Project Name: Pearl Fire Stations

Project Number: 22-099 & 22-108

ADDENDUM NO. 03

1
E220
POWER PLAN - FIRST FLOOR
Scale: 1/8" = 1'-0"

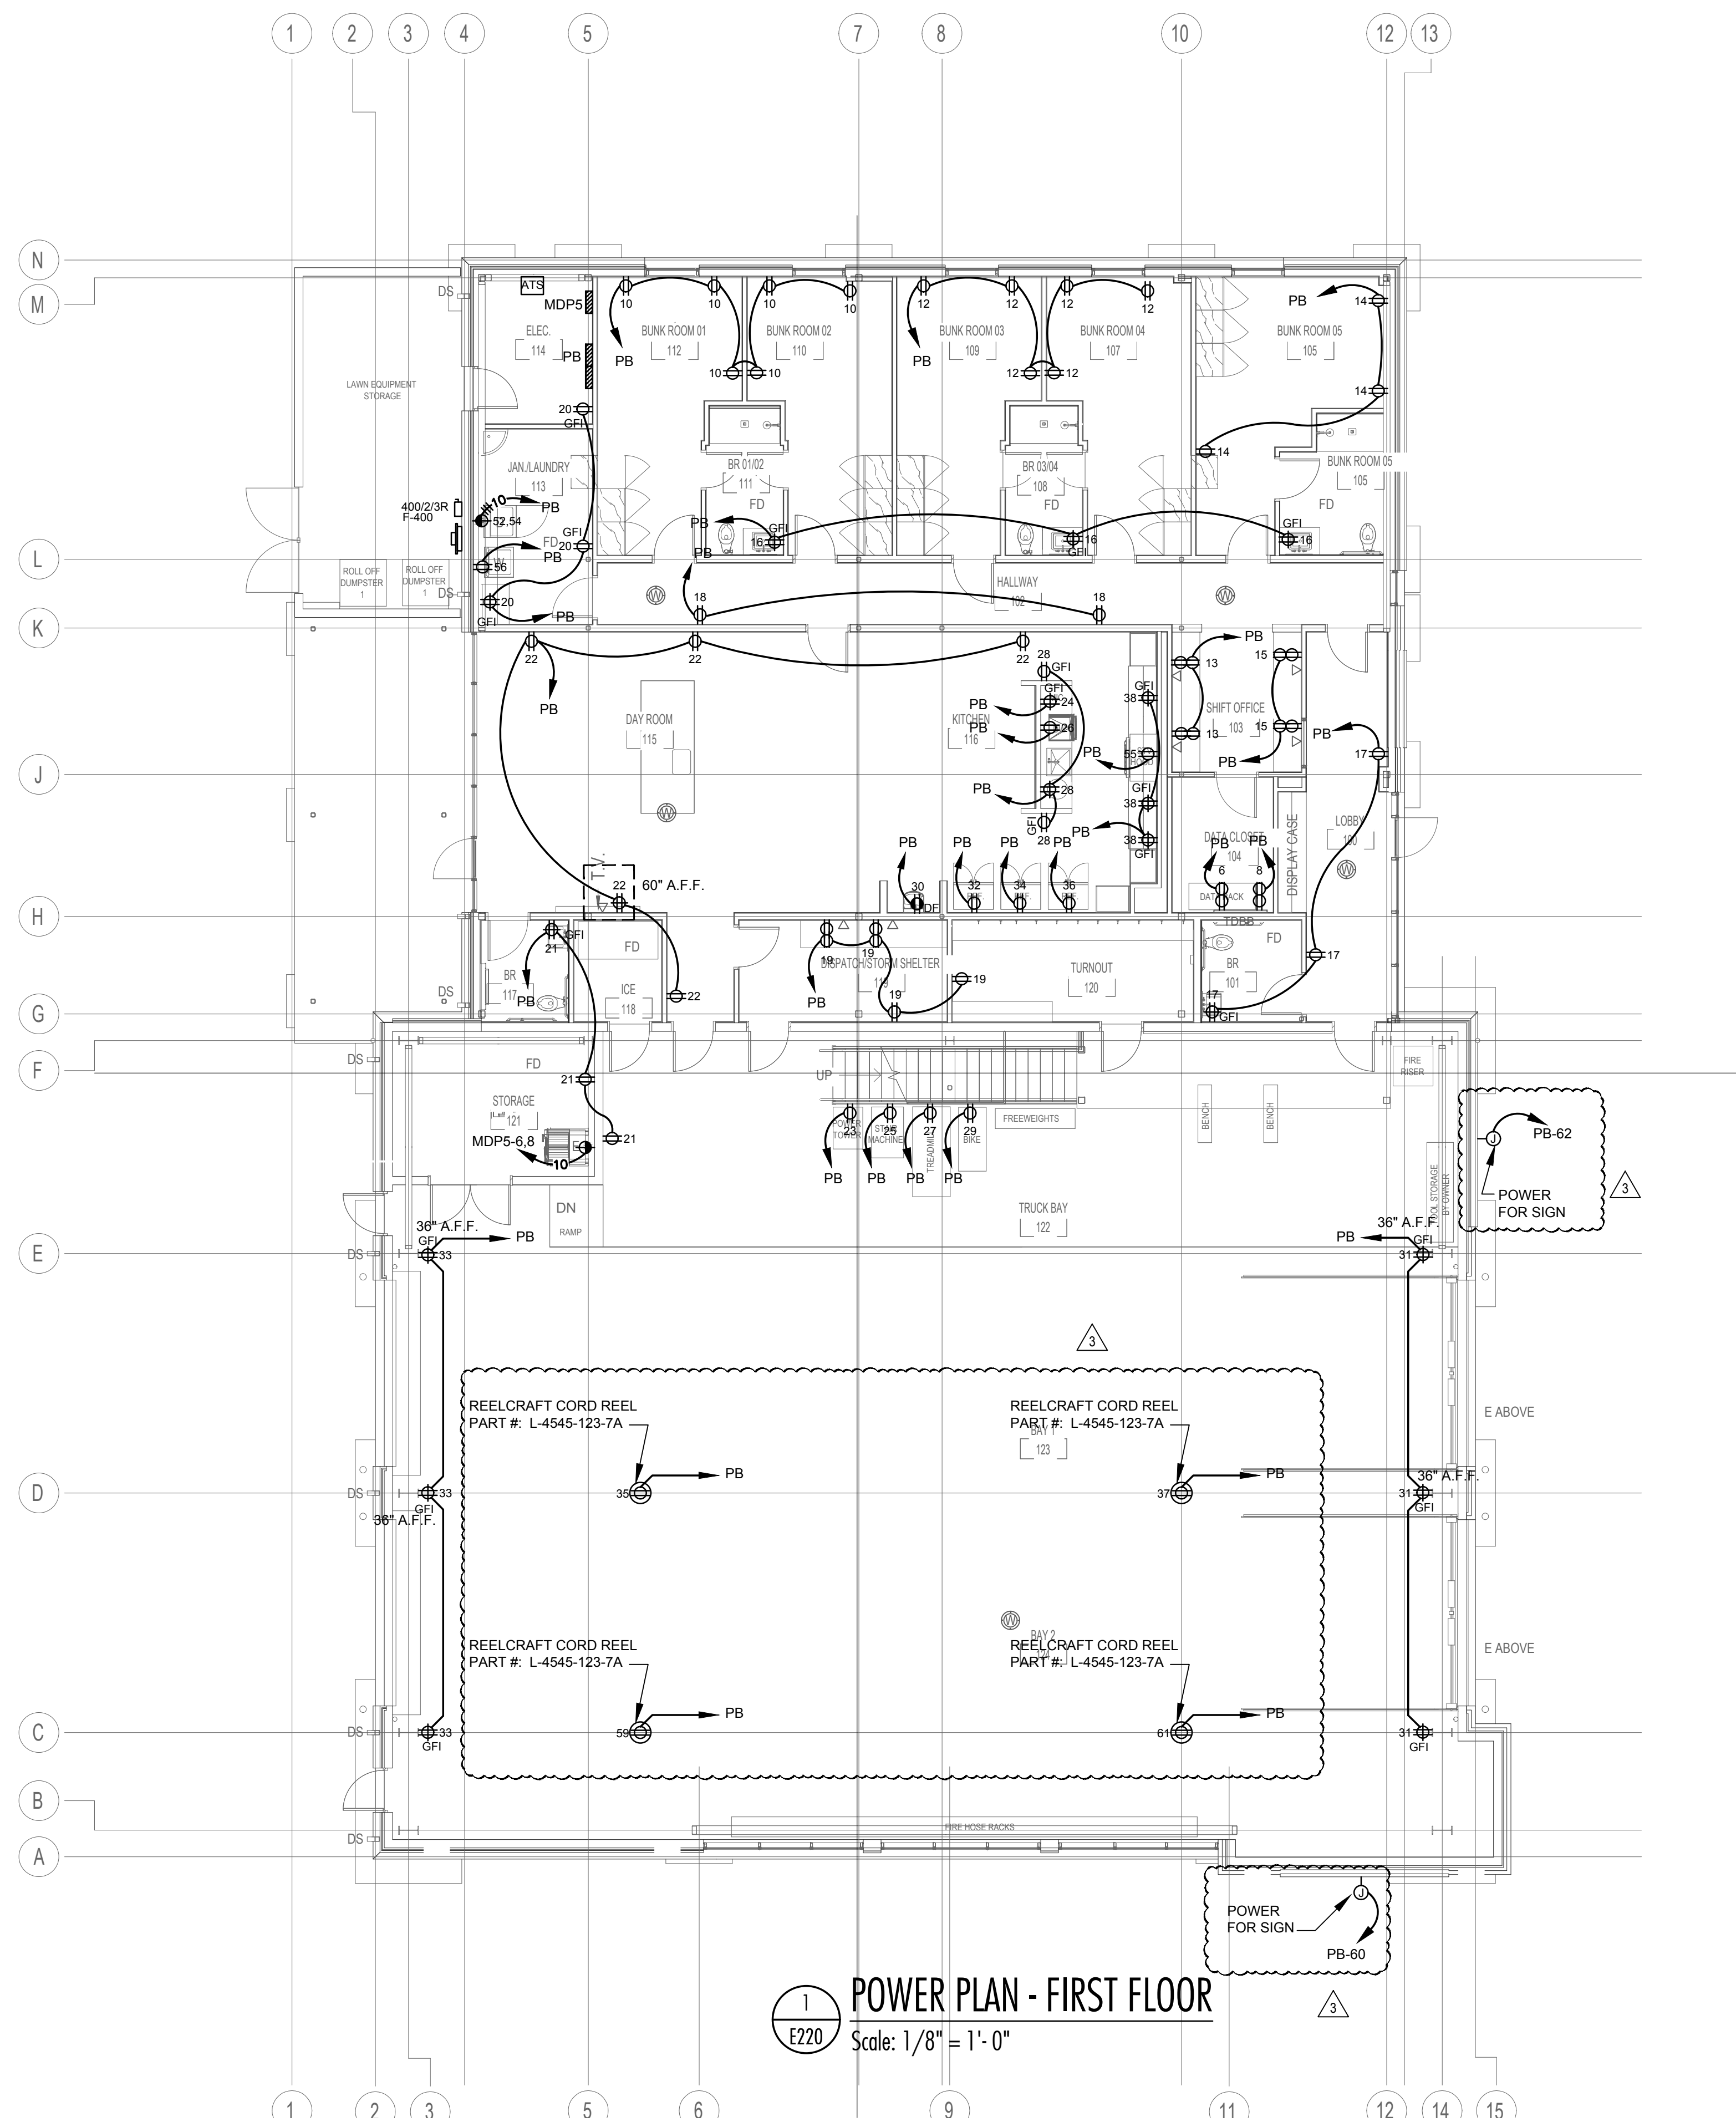
27	Assume Fire Hose Racks and all Exercise equipment including benches and mirror are N.I.C.?	7-Sep-23	Alvin Willey, Thrash Commercial Contractors, Inc.	Correct.
28	E210 & E220 show Cord Reels, Please advise if we are to provide them. If we are to furnish them, please provide more detail for what is needed.	7-Sep-23	Alvin Willey, Thrash Commercial Contractors, Inc.	See revised electrical drawings, issued via Addendum 3
29	E210 shows a symbol not shown on the electrical legend, are we to assume this is a floor box? Please provide more detail for what type is to be used.	7-Sep-23	Alvin Willey, Thrash Commercial Contractors, Inc.	See revised electrical drawings, issued via Addendum 3
30	Please verify if the following is acceptable for the plastic laminate faced cabinets. Can the cabinets bodies / semi-exposed surfaces be white melamine with a particleboard core with plastic laminate on the exposed surfaces and the doors & drawer front be plastic laminate on a particleboard core.	8-Sep-23	Sherman Dukes, Scanlon-Taylor Millwork	Provide as detailed.
